Change Order #03 - Tile Locations (8 feet of cover or less)

OWNER Stevens County Drainage Authority
CONTRACTOR Riley Bros. Construction, Inc.
Project: Stevens County Ditch No. 18 - Improvements
ENGINEER'S Contract No.: 19917
ENGINEER ISG

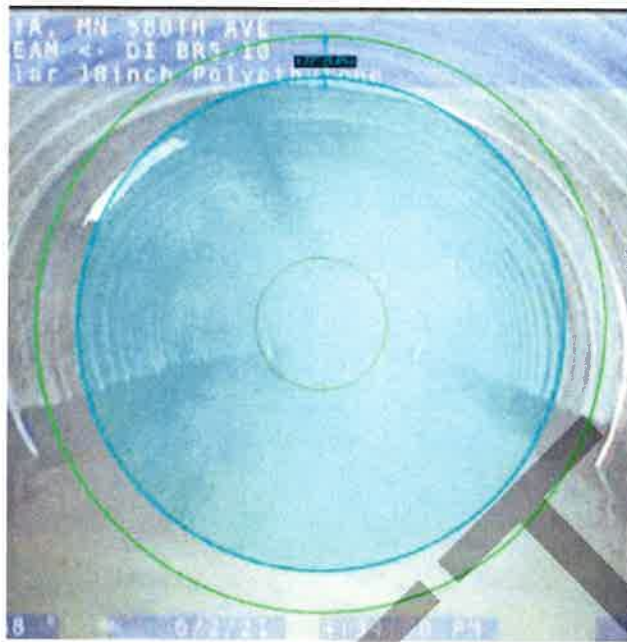
Branch Name	Tile Size (in)	Start Station	End Station	Length (ft)
Branch 1 Fork 5	10	63+80	65+30	150
Branch 1 Fork 5 Spur 1	18	0+00	4+50	450
	12	4+50	5+70	120
Branch 2	18	6+30	20+10	1380
	10	20+10	22+20	210
Branch 2	10	26+80	27+90	110
	18	3+00	10+00	700
Branch 3 Fork 2	18	13+30	13+60	30
	15	13+60	21+10	750
	15	21+40	21+60	20
	12	21+60	25+70	410
Branch 4	18	0+00	4+30	430
	18	6+20	15+90	970
	18	17+90	18+40	50
	15	18+40	21+50	310
	15	22+00	23+80	180
	15	26+90	28+00	110
	15	29+80	33+90	410
	12	33+90	37+30	340
Branch 4 Fork 1	12	37+70	38+15	45
	12	0+00	1+10	110
	12	1+70	10+00	830
	10	10+00	12+70	270
Branch 4 Fork 1	10	13+10	14+55	145

Branch Name	Tile Size (in)	Start Station	End Station	Length (ft)
Branch 5	18	83+70	93+50	980
	15	93+50	98+15	465
	12	98+15	100+60	245
	12	101+90	102+40	50
	10	102+40	106+65	425
Branch 5 Fork 1	15	0+00	0+80	80
	15	2+30	8+10	580
Branch 5 Fork 2	18	16+15	20+15	400
	10	20+15	23+80	365
	10	31+90	38+45	655
Branch 5 Fork 2 Spur 1	10	0+00	1+80	180
Branch 6	18	29+00	33+00	400
	18	34+30	40+00	570
	15	40+00	45+50	550
	15	53+50	57+00	350
	12	57+00	63+80	680
	12	64+40	65+20	80
	12	66+80	70+50	370
Branch 6 Fork 1	18	0+00	7+00	700
	15	7+00	8+20	120
	15	28+00	41+70	1370
Branch 6 Fork 1 Spur 1	15	42+10	43+35	125
	12	0+00	5+50	550
Branch 6 Fork 1 Spur 1	12	9+90	13+50	360
	10	1+00	19+50	1850
Clear Lake Branch Fork 2	18	69+10	75+80	670
	12	84+60	91+20	660
	12	92+10	92+75	65
